Memo

To: Central Otago District Council
From: Antoni Facey
CC:
Date: 3 July 2026
Re: **922 Luggate-Cromwell Road (Parkburn) ITA Peer Review**

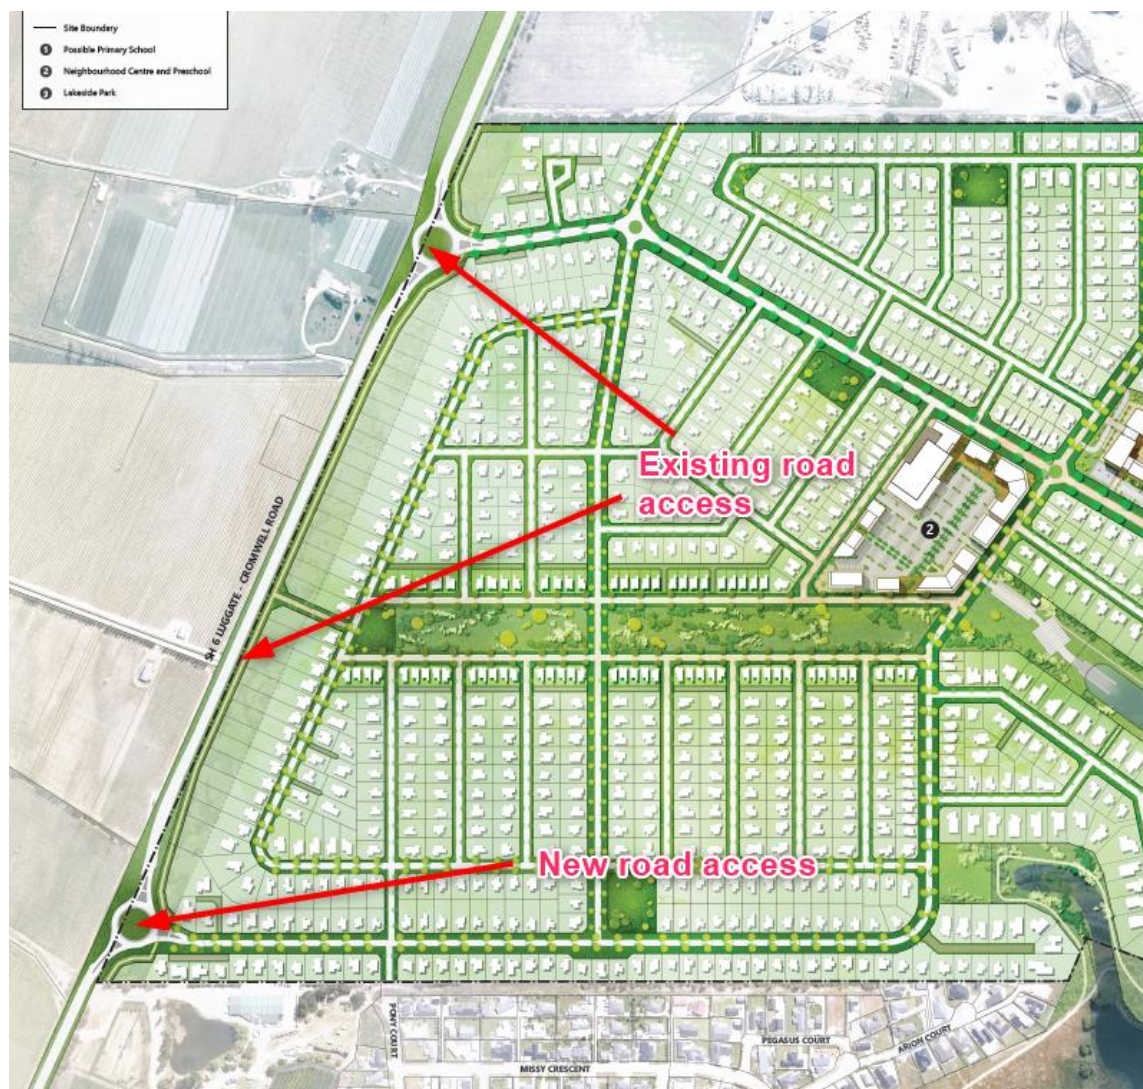
5. For clarity, the existing road access near the northern boundary is proposed to be upgraded to a roundabout as shown below while the southern existing access road near the centre of the site is proposed to be stopped and replaced by a new access road near the southern boundary to be controlled by a roundabout. The central road may be only a paper road that was never formed.
6. The southern roundabout will be constructed as part of stage 1 of the overall development while the northern roundabout is proposed to be developed at a later stage.

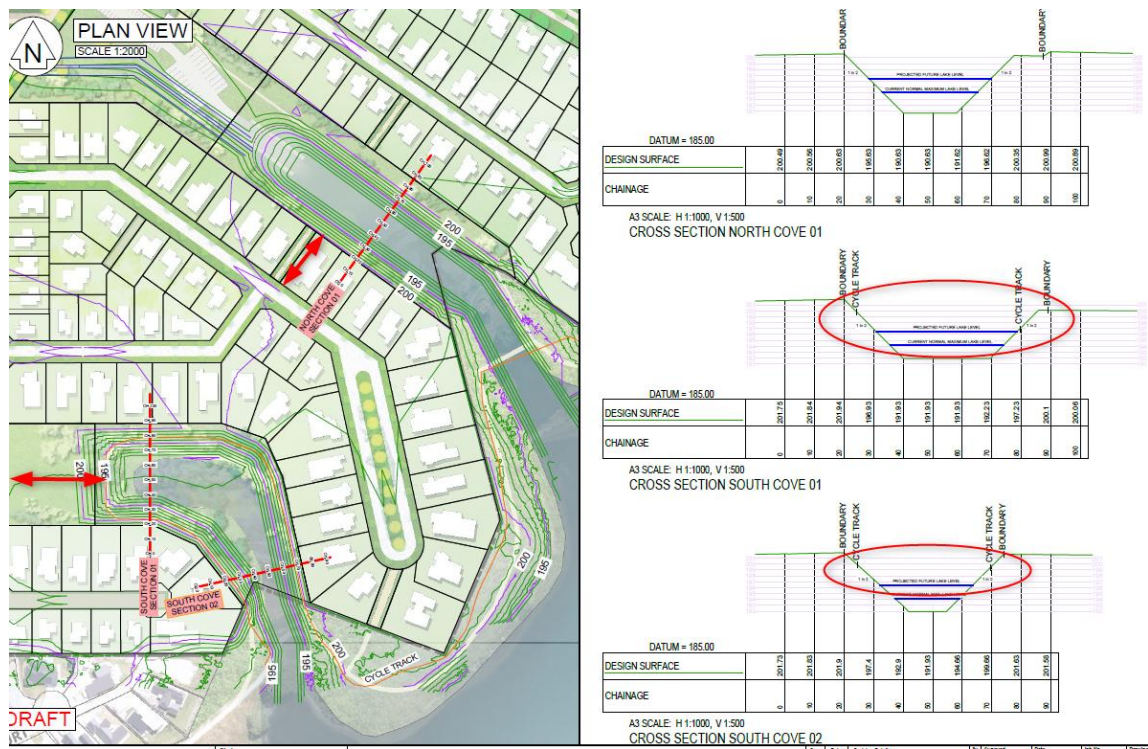
64. The HWR land to the north is currently used as an industrial site. Given that the timing of any proposed land use changes is unknown, it would be appropriate to consider this access as an industrial road with potential changes to be made before construction of the roundabout if the land use changes. In any case, construction activity to build the HWR development may require access through this route so it should be designed assuming semi trailers as the design vehicle. The roundabout

circled will need to be well designed to cater for this traffic and property boundaries should reflect this.
